Access Compliance Report

Public Rights-of-Way

(Curb Ramps)

Intersection ID: 26775	Main Street: CREEK_BEND_DR	Cross Street: ELM_CREEK_LN	Location: SW
ADA ID: 292F44620D27	Ramp Type: PerpDiag	Initial Pass/Fail: Fail	Overall Compliance: No
			Severity Score: 18.75

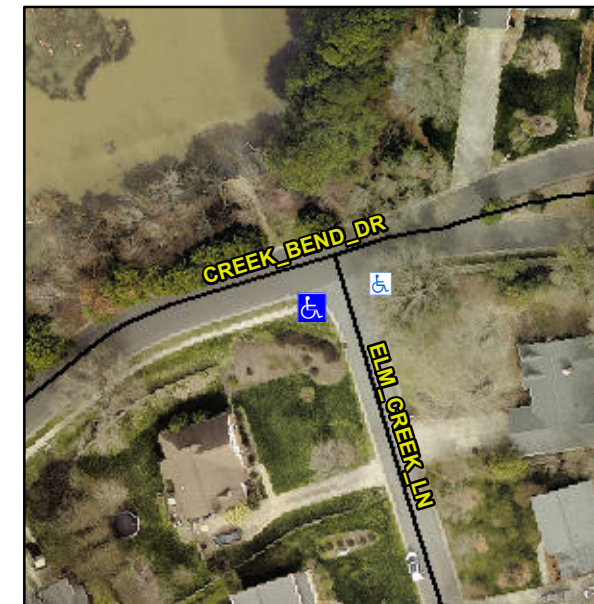
Not Found, R304.5.1, R304.5.3

Compliance	Description	Data	Compliance	Description	Data
N/A	Ramp Length (in)	92.0	Yes	Ramp Slope (%)	5.9
No	Ramp Width (in)	33.0	No	Ramp XSlope (%)	3.9
N/A	Flare Type LT	N/A	N/A	Flare Type RT	N/A
N/A	Flare Slope LT (%)	N/A	N/A	Flare Slope RT (%)	N/A
N/A	Flare Traversable LT?	N/A	N/A	Flare Traversable RT?	N/A
N/A	Landing Length (in)	N/A	N/A	DWS Provided?	N/A
N/A	Landing Width (in)	N/A	N/A	DWS Contrast?	N/A
N/A	Landing Slope (%)	N/A	N/A	DWS Length (in)	N/A
N/A	Landing X Slope (%)	N/A	N/A	DWS Full Width?	N/A
N/A	Landing Curb? (Y/N)	N/A	N/A	DWS Offset (in)	N/A
N/A	Shared Landing?	N/A			
N/A	Gutter Ponding?	N/A	N/A	Gutter Slope (%)	N/A
N/A	Gutter Lip Ht (in)	N/A	N/A	Gutter X Slope (%)	N/A
N/A	Painted X Walk1?	No	N/A	Painted X Walk2?	No
	X Walk 1 Direction	To E		X Walk 2 Direction	To N
N/A	X Walk 1 Width (in)	N/A	N/A	X Walk 2 Width (in)	N/A
	X Walk 1 Slope (%)	2.3		X Walk 2 Slope (%)	1.2
	X Walk 1 X Slope (%)	0.1		X Walk 2 X Slope (%)	3.5

Remove & Replace Curb Ramp With Two New Directional Ramps or Equivalent.
